BULLETIN T-64-41

SUBJECT: TRIUMPH TR-4 WINDOW
WINDER REGULATOR

DATE: DECEMBER 10, 1964

A-A

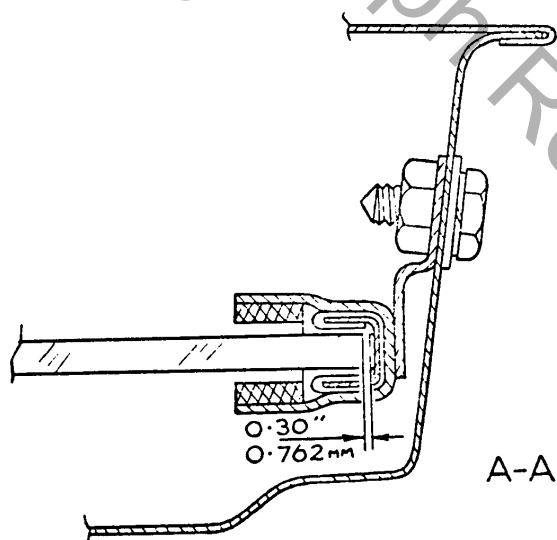
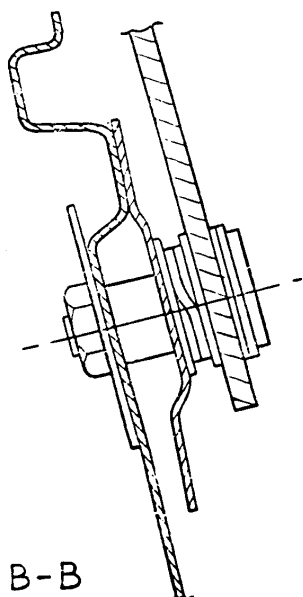
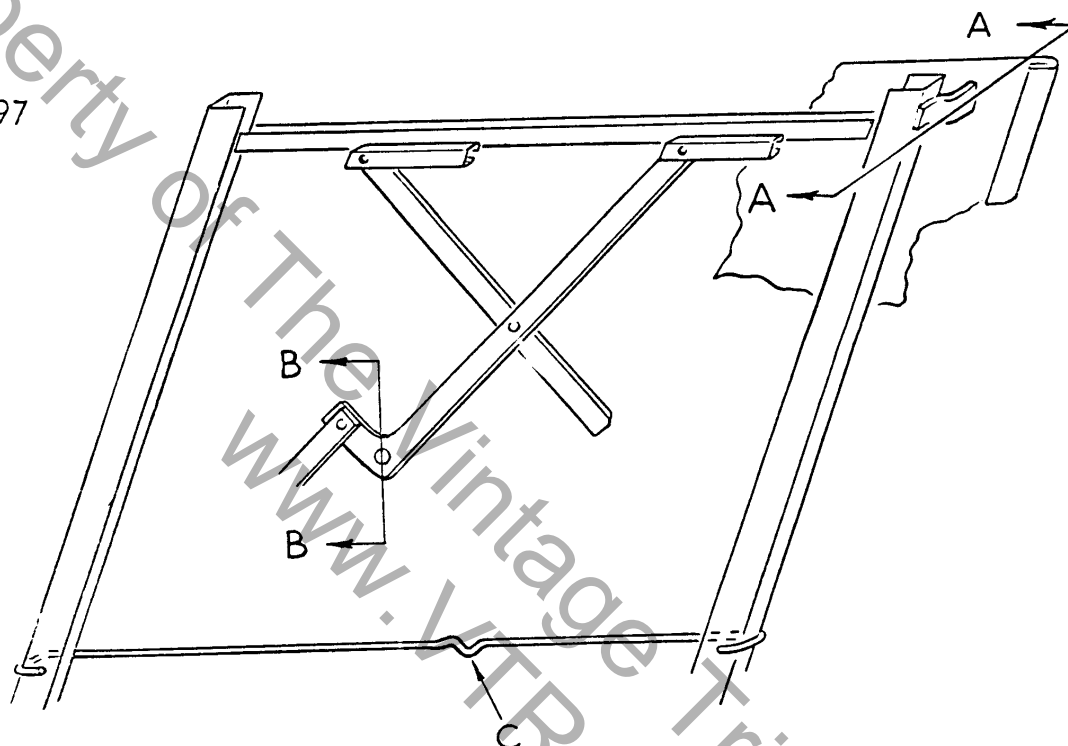
1. Remove trim panel.
2. Raise window and check the clearance of the glass fore and aft in the top of the rear channel. The recommended clearance is .030" which should be maintained for the whole length of the channel. Excess clearance will allow tilting and the jamming of the glass and insufficient clearance will produce stiff operation. Clearance can be obtained by the use of packing washers between the inner door panel and top channel bracket (see illustration A-A).

3. Adjust bottom brackets and crimp the tie rod to ensure that the channels are parallel (illustration C).
4. Remove regulator pivot pin nut and delete spring washer under head of nut. Add washer WP0119 1/2"x 7/8" x .050" behind head of pivot bolt and additional washer WP0160 5/16" x 1 5/8" x 16 S.W.G. behind head of nut (illustration B-B).

5. Tighten nut sufficiently to allow ease of operation and peen or center pop end of thread.
6. Refit trim.
